A REVIEW OF THE MILLSTONE-3 PROBABILISTIC SAFETY STUDY

Abel A. Garcia, Principal Investigator

May 30, 1984

Prepared for
Division of Safety Technology
Office of Nuclear Reactor Regulation
U. S. Nuclear Regulatory Commission
Washington, DC 20555

Figure 3.2-1 Large LOCA Event Tree

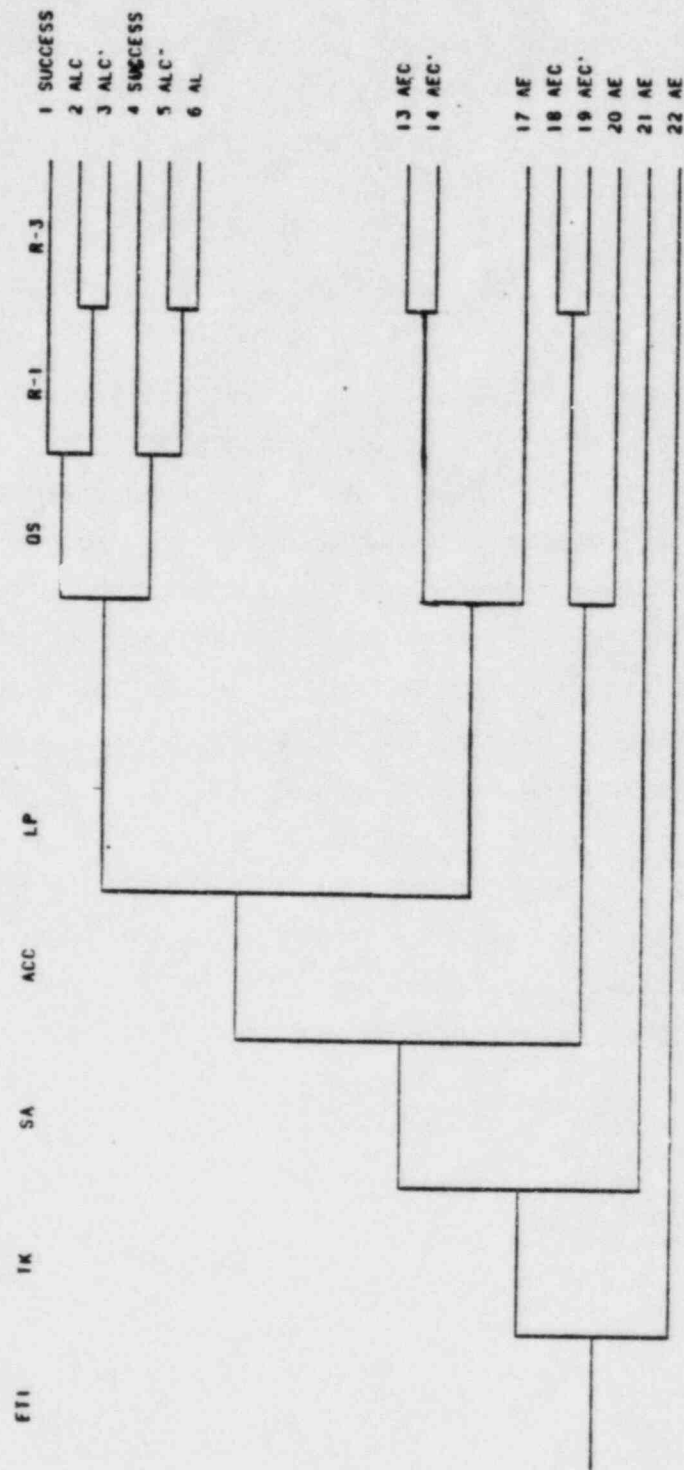
The PSS assumes that high pressure injection (HPI) is sufficient to provide coolant injection for the large LOCA event. Previous PRAs have usually assumed that the HPI system is not capable of supplying this function for large breaks. Part of the reason is that these systems are usually not sized to provide the amounts of flow required to replenish the coolant lost during large LOCAs. This, however, is only a secondary concern. The major concern is that the HPI pumps are designed to provide flow against relatively high pressure. They utilize a lot of power to produce the required head. When a pump of this type pumps against minimal or no head, as is the case for a large LOCA, the power which usually goes to overcoming the pressure at the pump discharge is converted to greatly increased flow. The tendency in this case is for the pump speed to increase, due to the decreased resistance, beyond the point at which the pump is still capable of drawing sufficient amounts of water through the suction lines. At this point, pump cavitation would occur and the pump would trip on low suction pressure or overspeed. If pump trips are not provided, the pumps would be destroyed. In either case, the pumps would not be able to provide coolant to the RCS. There is no reason to believe that the Millstone pumps are immune to this phenomenon, and the assumption that HPI could supply injection during large LOCAs is not justified. The event tree shown in Figure 3.2-1 has been modified to reflect this judgment.

In addition, the original event tree showed a decision point for event R-1, low pressure recirculation cooling in sequences where no injection cooling was available. Due to the design of this plant, it is possible for this to occur. However, this does not change the outcome of the event, as can be seen on the tree. Regardless of the state of R-1, an early core melt still occurs. Although the presence of this decision point on the tree does not impact the results of the study, it has been removed from our modified tree because it is meaningless.

Figure 3.2-3 Small LOCA Event Tree (Sheet 1 of 2)

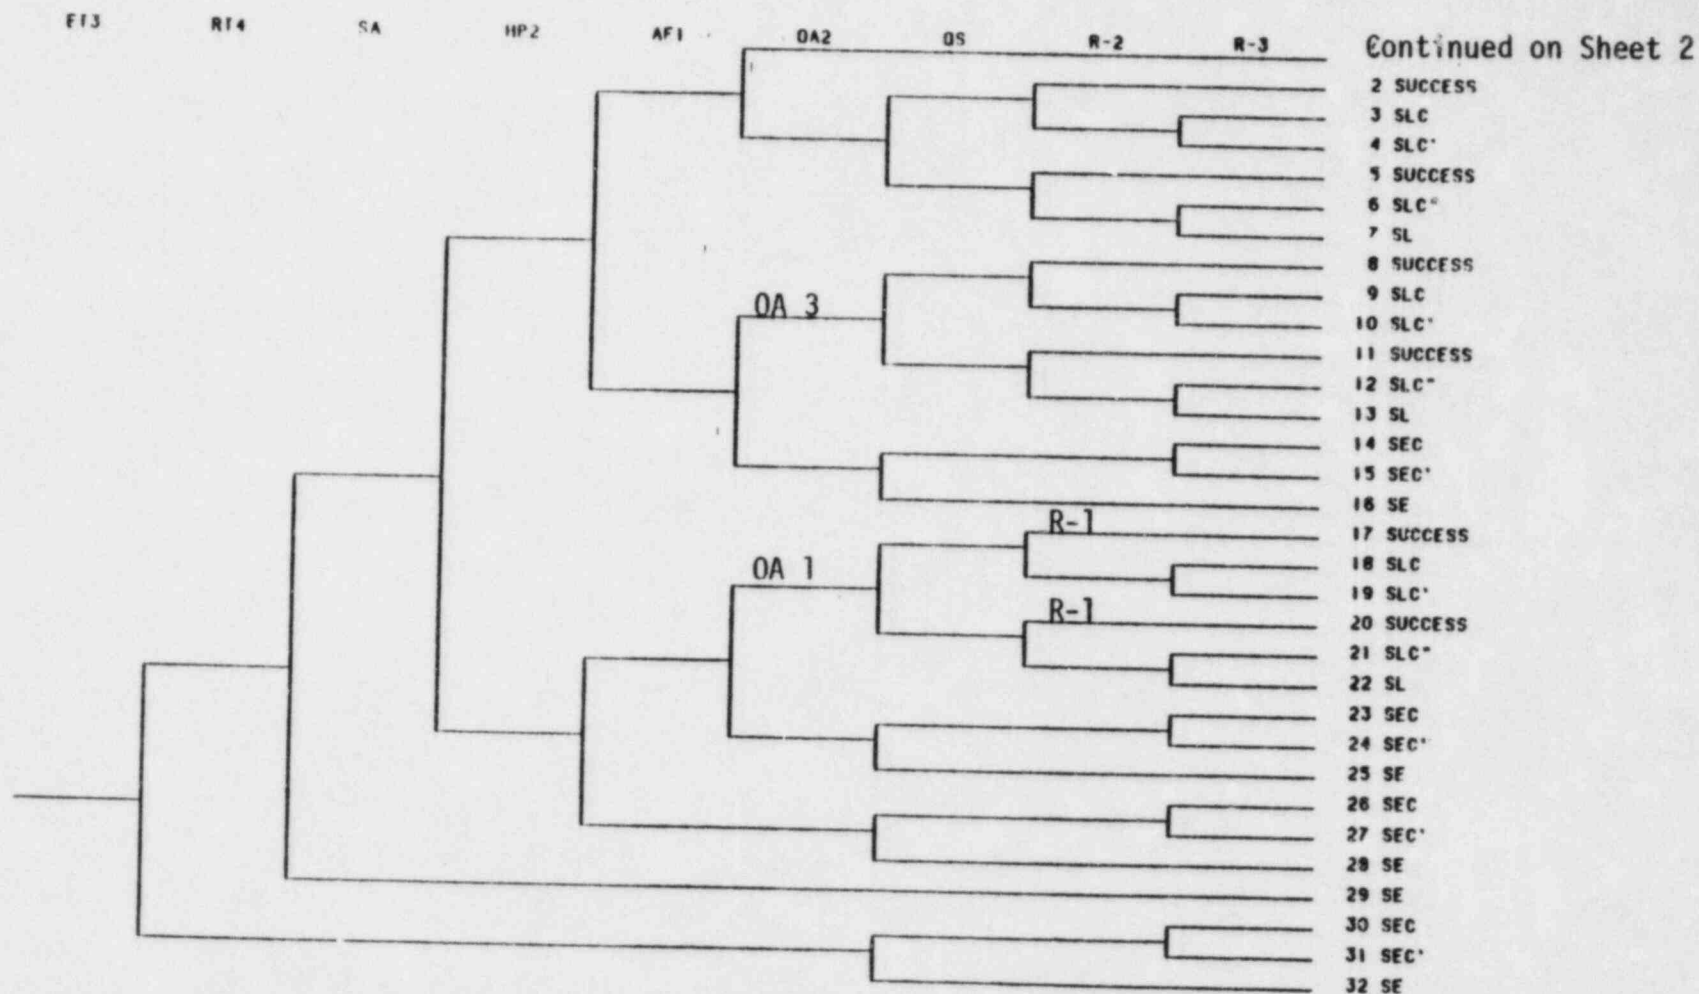
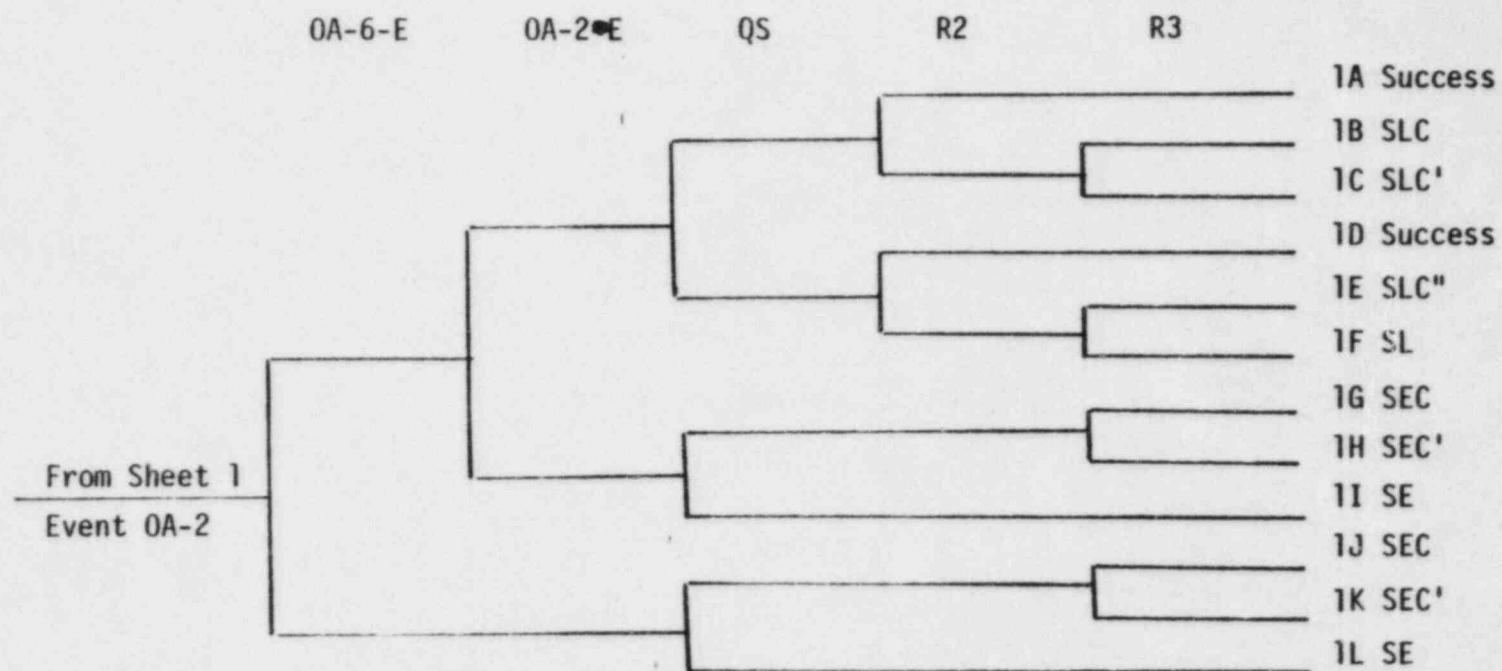
the applicable trees, which are shown in Figures 3.2-3 and 3.2-4, have been modified to reflect the eventual need for recirculation during these event sequences.

Figure 3.2-5 Steam Generator Tube Rupture Event Tree

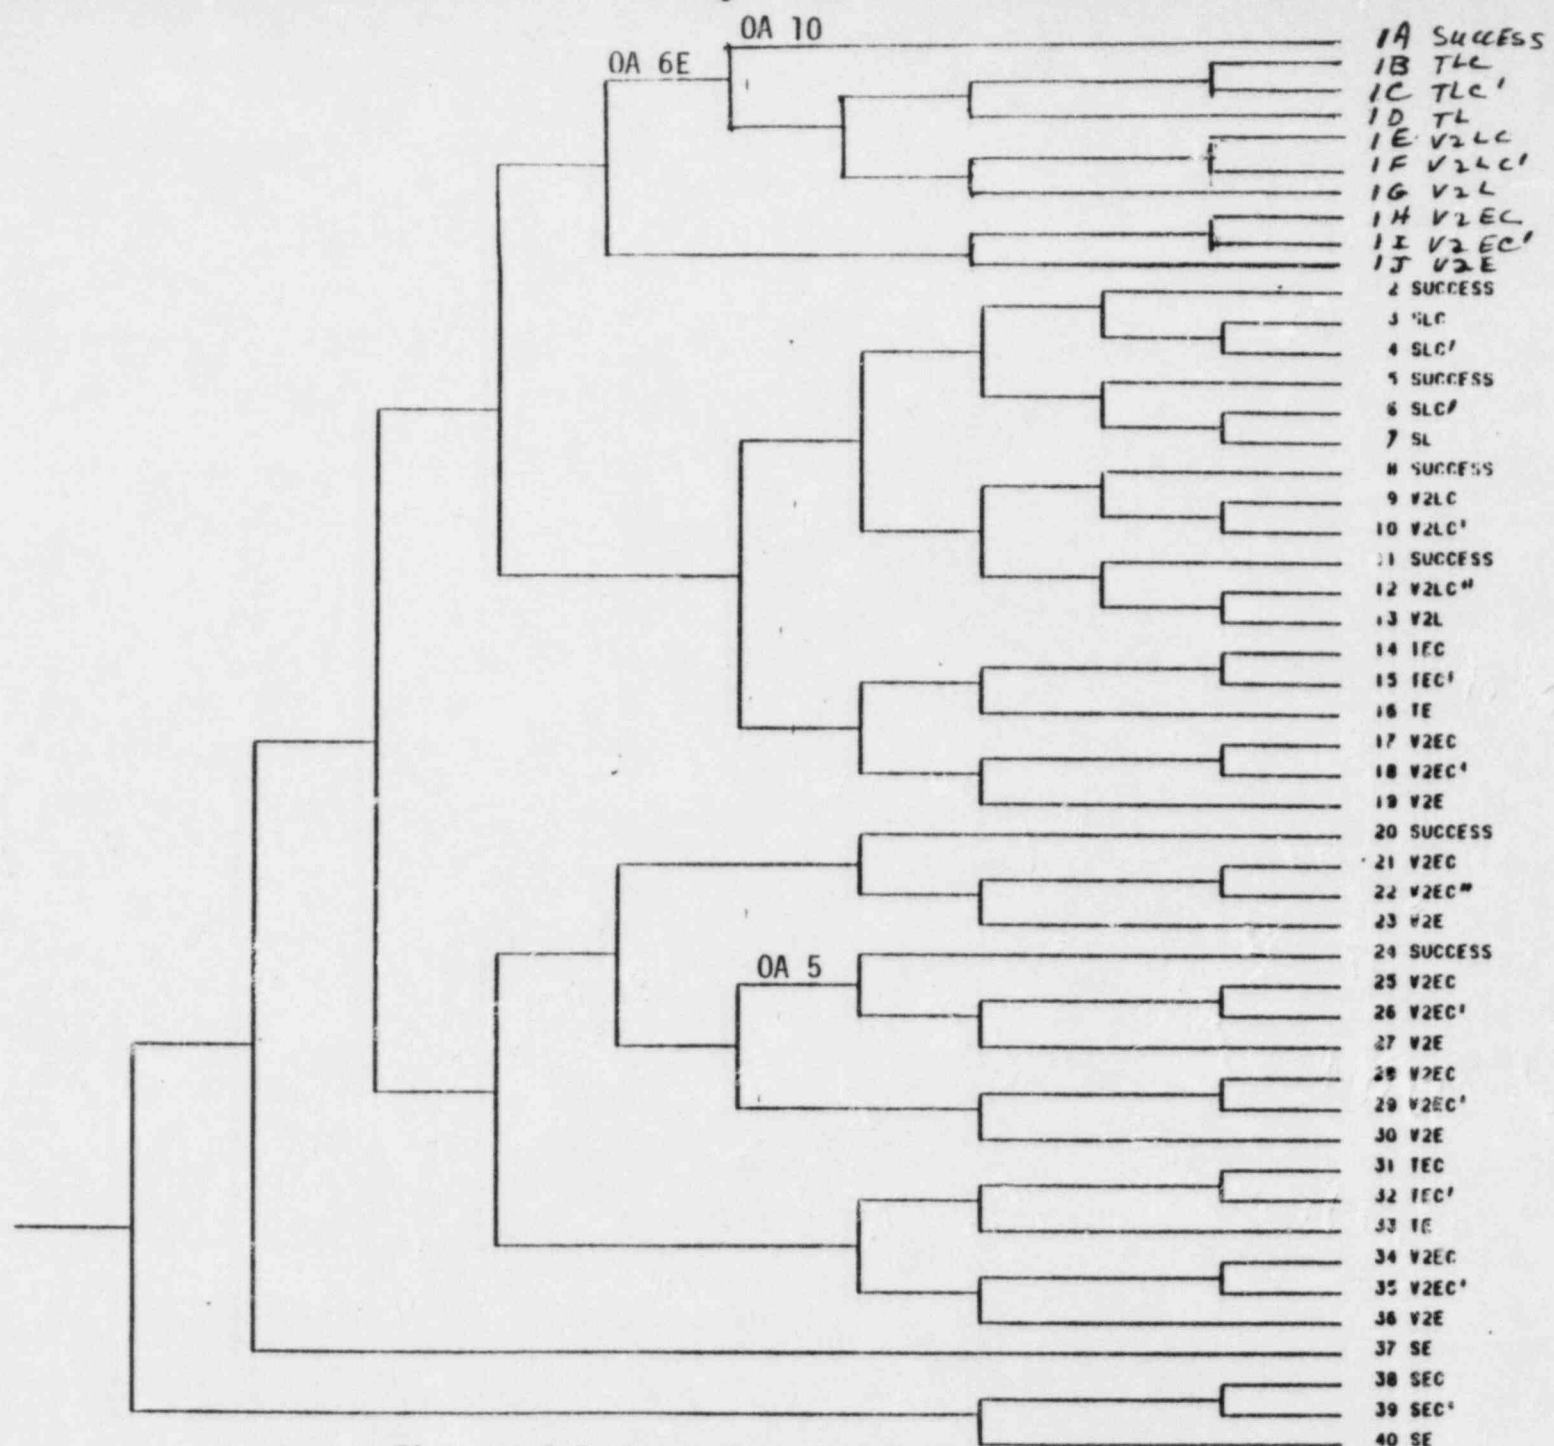
Another assumption the PSS makes is that if HPI and AFW are both available following a SGTR Event, the event is terminated successfully without further action. This does not seem reasonable, since the primary would be kept at high pressure by the HPI pumps, and water would continuously be pumped out of the RCS and into the steam generator. Eventually, the RWST would empty with the RCS still at high pressure and no recirculation available. It seems that some additional operator action is required to gain control of the scenario following the start of HPI and AFW. Discussions with plant personnel indicated their agreement that some operator action is required. The emergency procedure guideline for this event instructs the operator to reduce pressure and terminate HPI flow. It does not imply that this is required to prevent core melt, but is intended rather to reduce the release of primary coolant (and thus radioactivity) through the secondary. The reviewers, however, consider this action to be ultimately required to prevent core melt due to pumping the entire contents of the RWST out of the containment. A new operator action has been defined to cover this case as described below.

The SGTR tree shown in Figure 3.2-5 has been modified to include this action.

Figure 3.2-6 Steamline Break Inside (& Outside) Containment Event Tree

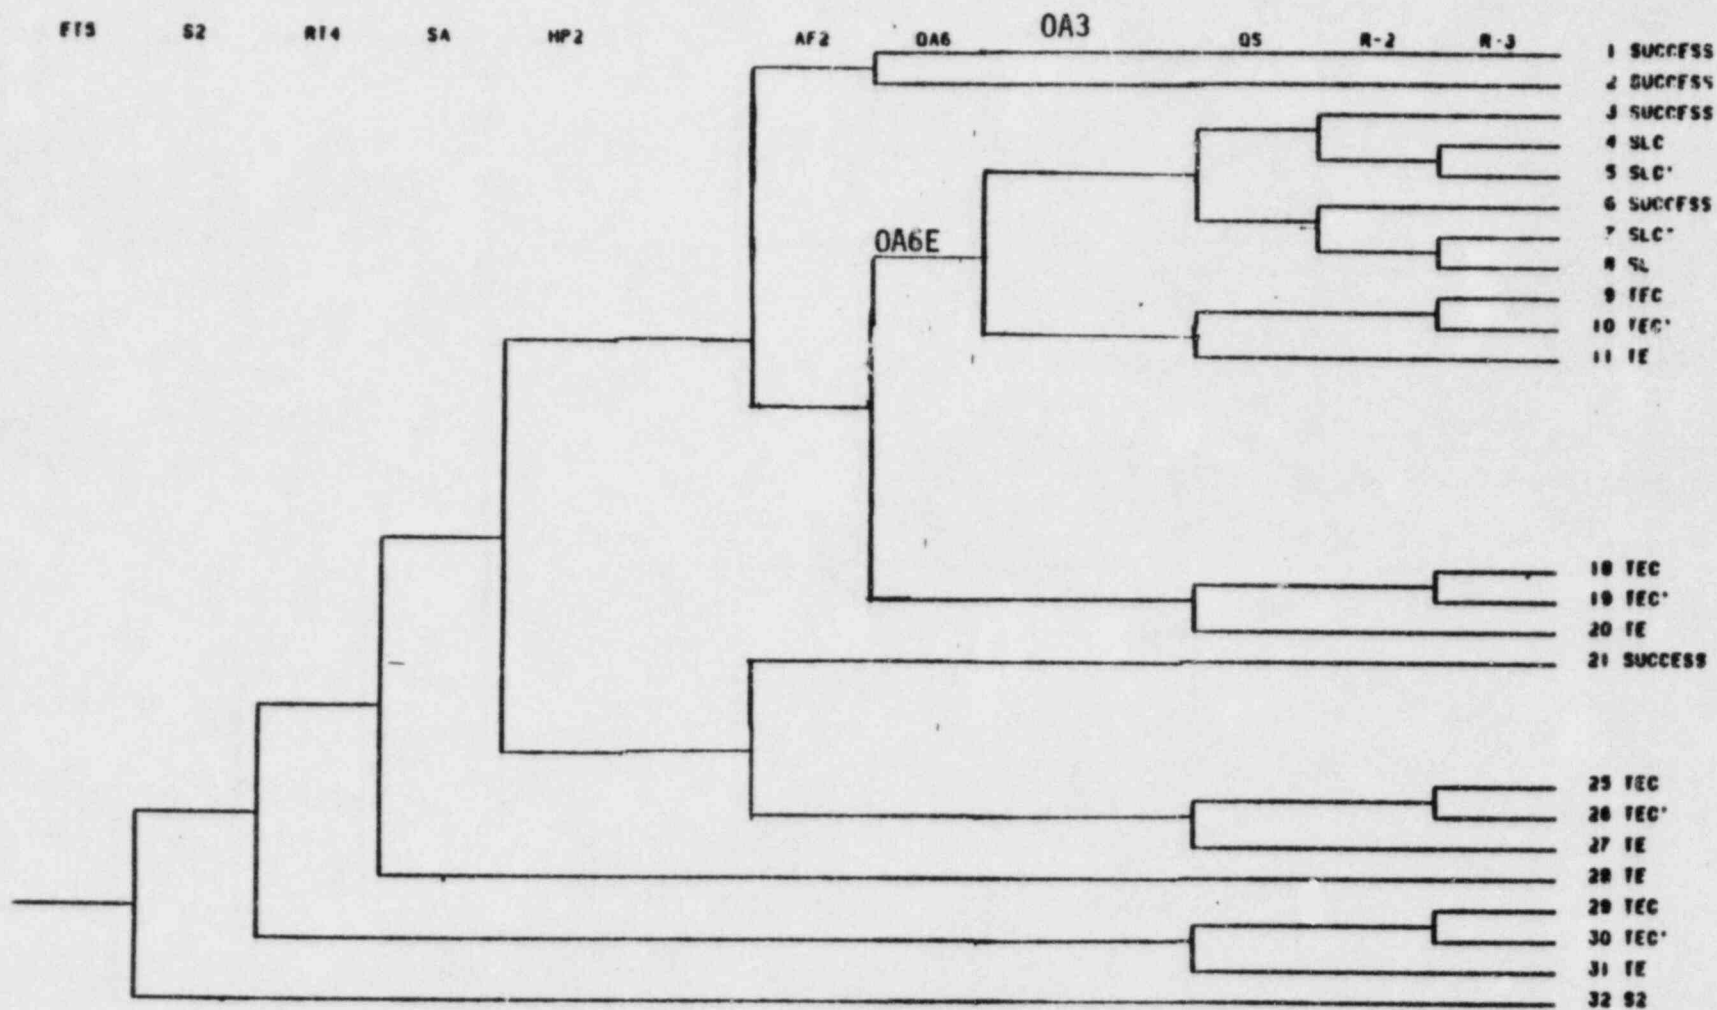
For steamline breaks, the PSS assumes that the failure of main steam isolation (MSI) results in the failure of auxiliary feedwater. The basis for this assumption is unclear, and there seems to be no reasonable explanation for it. In most previous PRAs, main steam isolation has not been assumed to have any affect on the availability of safety systems and was considered only as a key part of the containment isolation system. In the case of auxiliary feedwater, the worst one could assume is that the failure of MSI could affect the availability of the steam turbine-driven AFW pump due to steam diversion, although this would be unlikely since very little steam is required to operate this pump. Specifically, for the most likely break, a stuck open secondary steam relief valve, the flow diversion would be small enough that the steam supply to the turbine would still be sufficient to provide the required feedwater flow regardless of the state of MSI. For the less likely case of a if none of the steam generators were isolated from the break. In either case, the ability of the motor-driven pumps to supply water to the steam generators would not reasonably be expected to be affected. As long as water is supplied in sufficient amounts, cooling will be established regardless of main steam isolation. This assumption is conservative and unjustified. The steamline break trees shown in Figure 3.2-6 have been modified to reflect this judgment.

Figure 3.2-8 Loss of Power Conversion System Event Tree

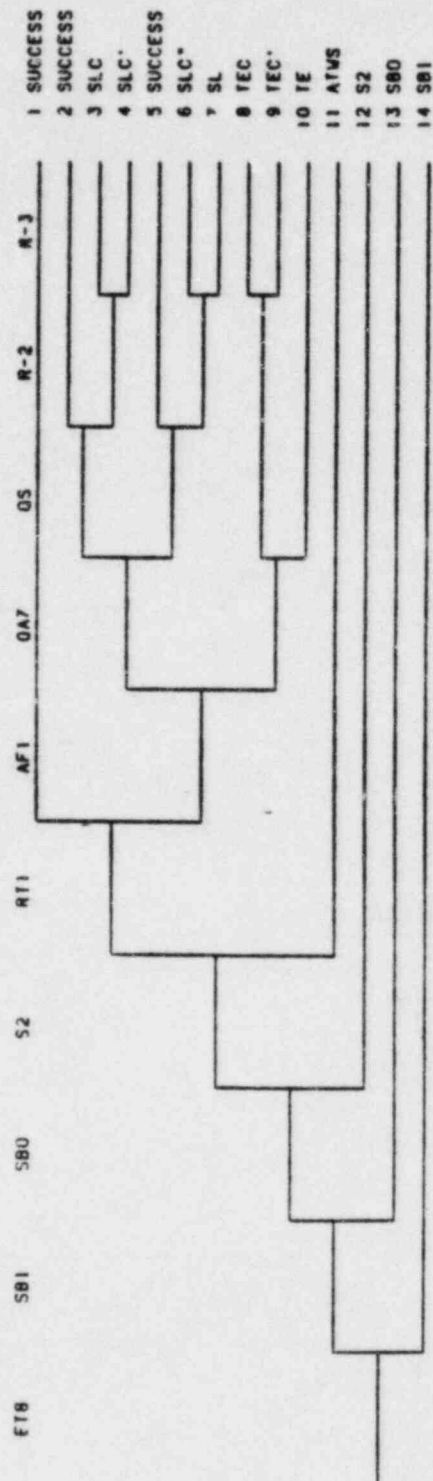
The loss of feedwater event tree from the PSS shown in Figure 3.2-8 can be used to evaluate the loss of PCS events. This tree would be used not only to evaluate the event class referred to as loss of PCS, but also all other transient event classes which result in loss of PCS. In this case, these would be all of the other transient events included in the study (e.g., loss of offsite power, loss of service water, loss of an electrical bus, etc.).

Figure 3.2-10 Spurious Safety Injection Event Tree

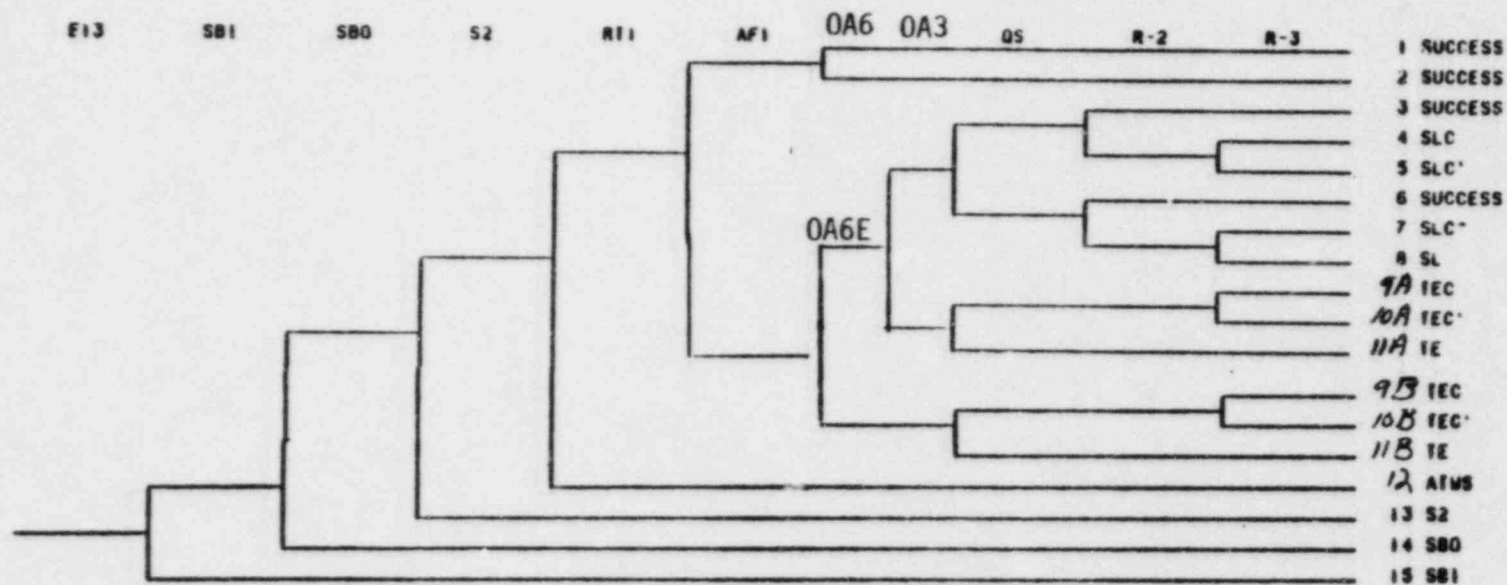
The use of operator action OA-7, primary bleed and feed, is incorrect on this tree. While bleed and feed cooling is valid for this event, OA-7 includes the unavailability of HPI in its unavailability value. The initiating event itself implies that HPI is already operating. Further, the other events on the tree, such as OA-6, assume that HPI is already operating. Thus, the proper event to use on the tree would be operator action OA-3, primary bleed. This would serve to establish bleed and feed cooling. The modified event tree is shown in Figure 3.2-10.
